**PLANNING DIVISION REPORT  
DEPARTMENT OF PLANNING AND COMMUNITY  
AND ECONOMIC DEVELOPMENT  
Of July 31, 2007**

**RE: I.D. # 07109, Conditional Use Application – 201 S. Gammon Road**

**Engineering Statement  
Prepared for the City of Madison  
Re:  
Proposed Cingular Wireless Tower Site #WI-2024  
201 South Gammon Road  
Madison, Wisconsin**

**Figure 1 – Network Coverage Without Proposed Site**

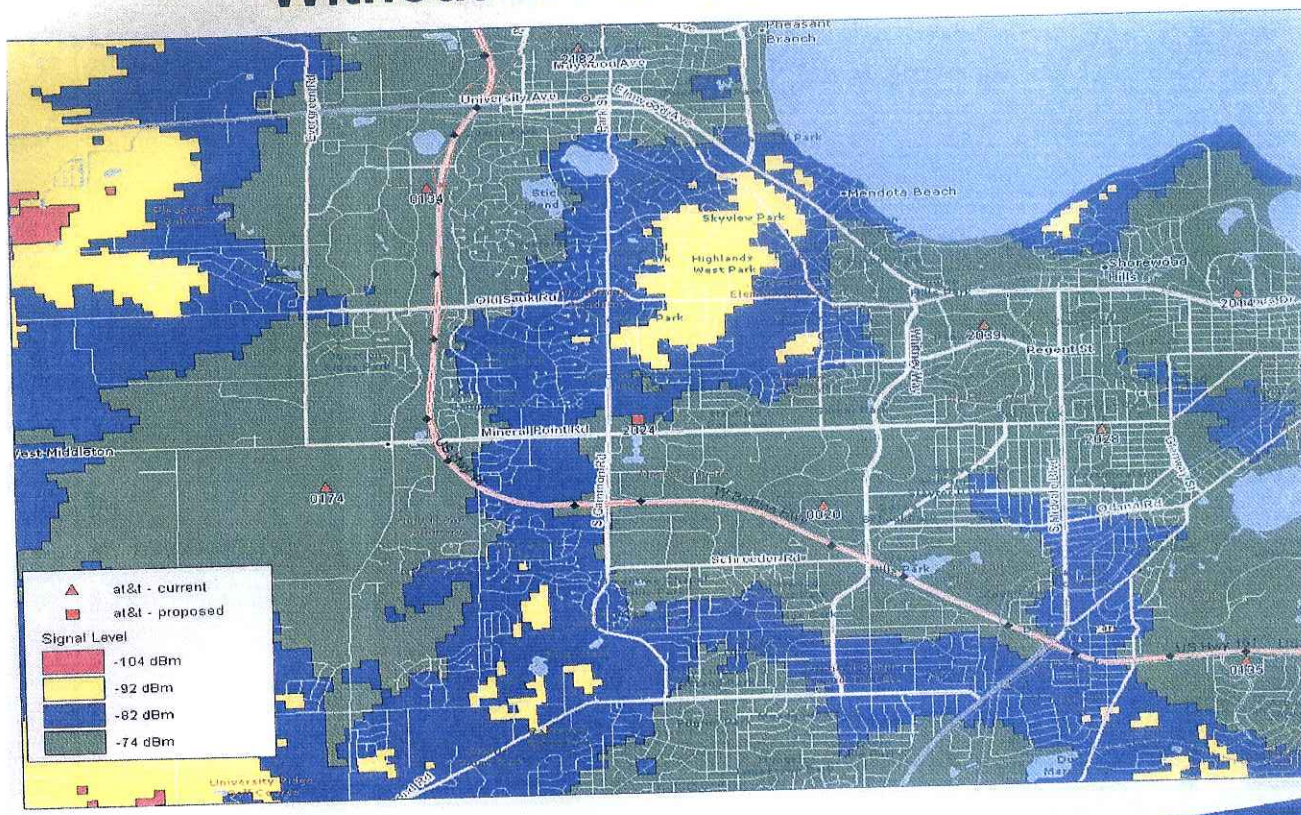
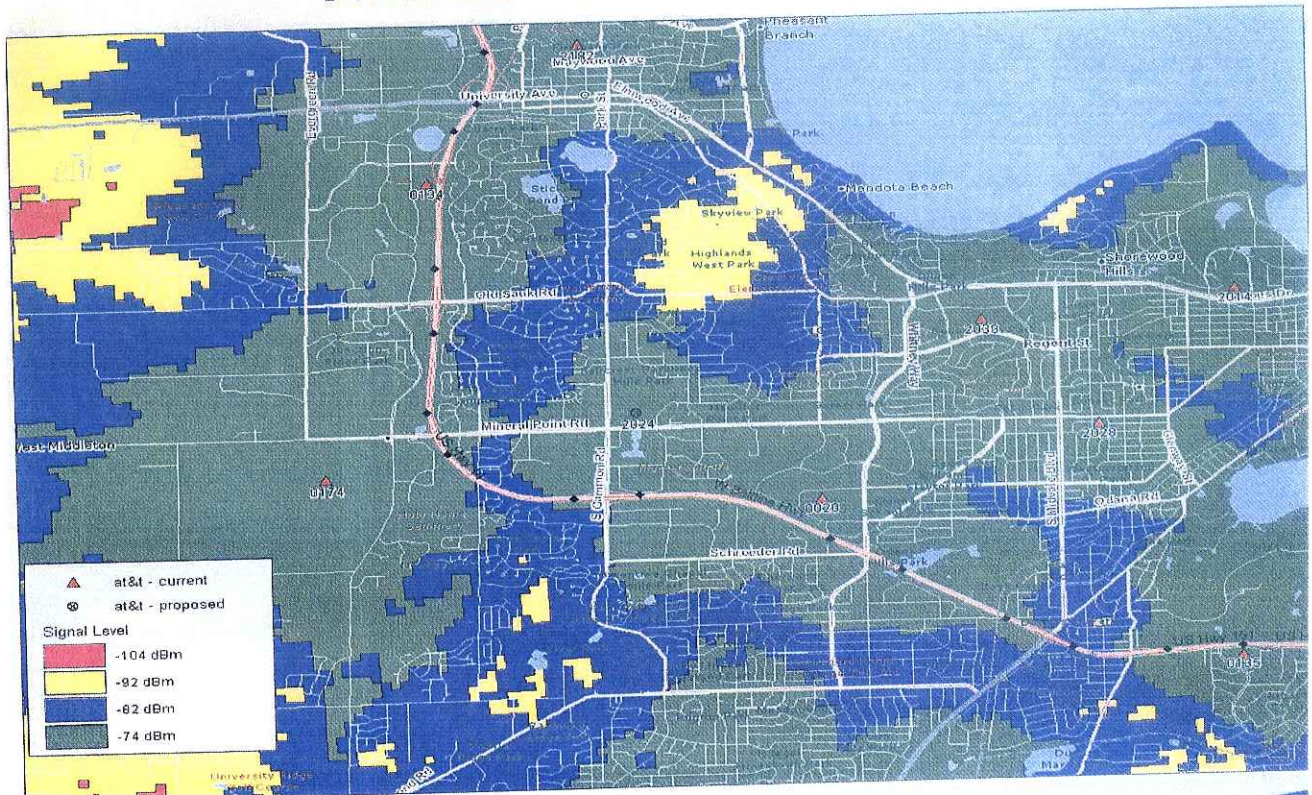
A propagation study conducted by Cingular Wireless, and verified by this consultant, shows the current and proposed coverage of the City of Madison. Figure 1, attached, shows the existing Cingular Wireless coverage in the area, while Figure 2 is a map of the Cingular Wireless coverage after the proposed site is activated.

There would be a substantial area that will be upgraded from "fair coverage" to "excellent coverage" as a result of the new site (see Figures 1 and 2). This site would assure continuous coverage in and around the local area and enhance service to a large number of area businesses by increasing call capacity in the area.

Figure 3 – AT&T Cingular Sites in Dane County

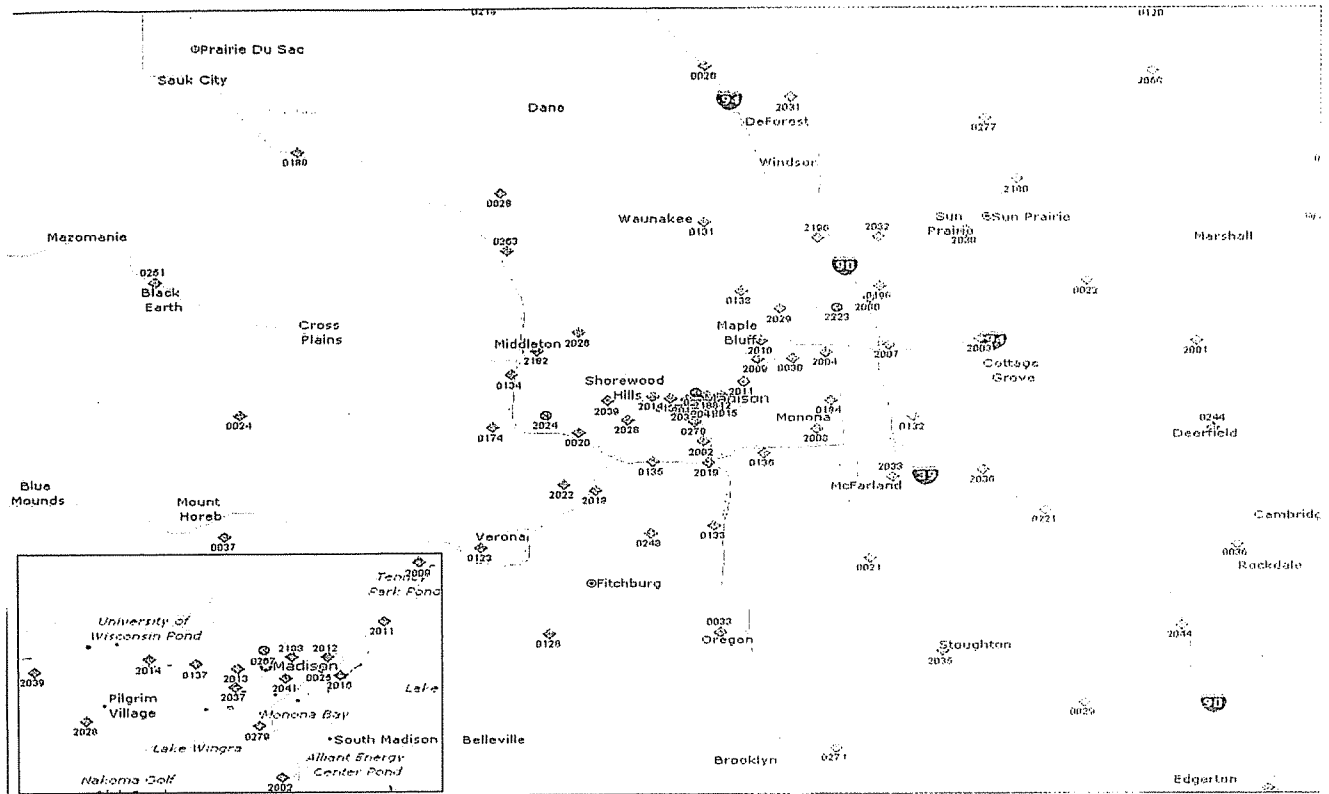
The proposed site is quite well positioned between the adjacent Cingular Wireless sites. The propagation map (Figure 2) shows the adjoining sites that comprise the existing Cingular Wireless network.

Figure 4 – Antenna Structure Elevation Drawing

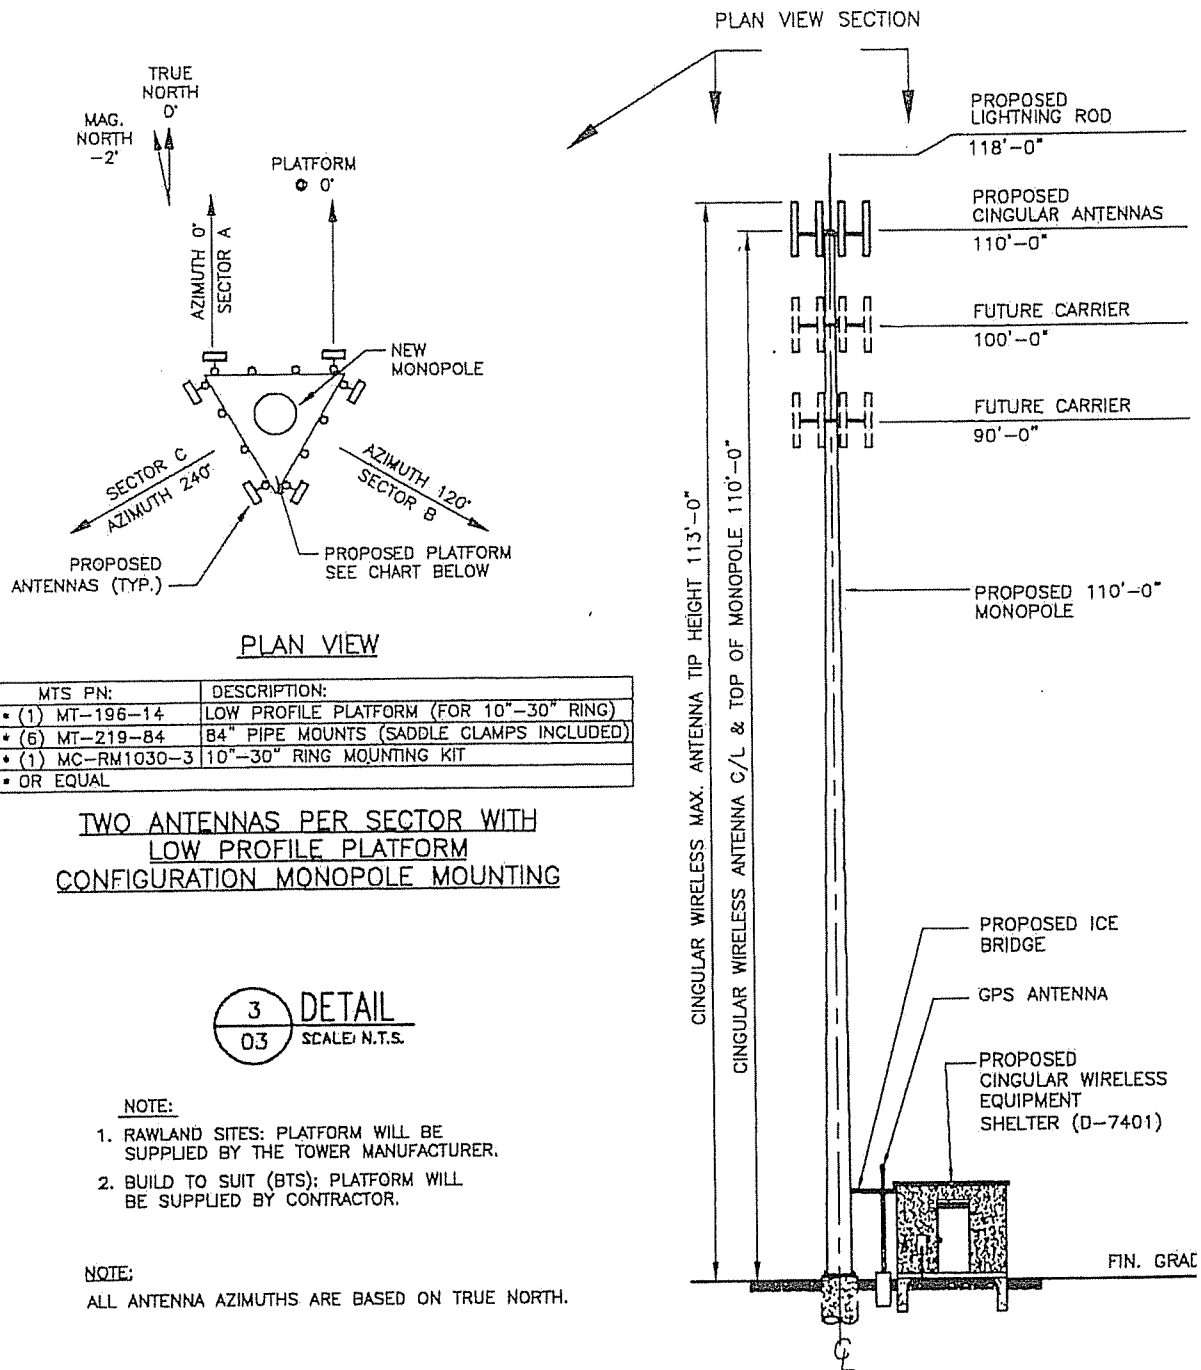
According to the elevation diagram, the proposed site will utilize a panel style 6-element antenna array (6' tall and 1" wide) mounted at approximately the 110-foot level of a monopole tower, representing essentially omnidirectional coverage. The tower height proposed, 110 feet AGL, has been requested by Cingular in order to adequately serve the area. The pole will be strong enough to support two additional carriers, at 100' and 90' AGL.

Cingular Wireless has provided engineering design drawings stamped by a Licensed Architect. These plans should be reviewed by a licensed structural engineer to verify that the latest EIA/TIA standards are being observed and that the tower will support the antennas of the two possible future wireless co-locators.

1. A licensed Professional Engineer should approve the finished tower, and certify that the tower can support at least a total of three antenna arrays.
2. Cingular Wireless should submit to the city of Madison the Determination of No Hazard from the FAA for the total tower height of 118 feet AGL (110-foot tower plus 8 feet for antennas and lightning rod), if it has not already been done. Also, contact with Wisconsin DOT should be made prior to construction, if it has not already been done.
3. Cingular Wireless should utilize a galvanized or painted finish on the tower to minimize visual impact ("stealth" finish), if permitted by WisDOT.
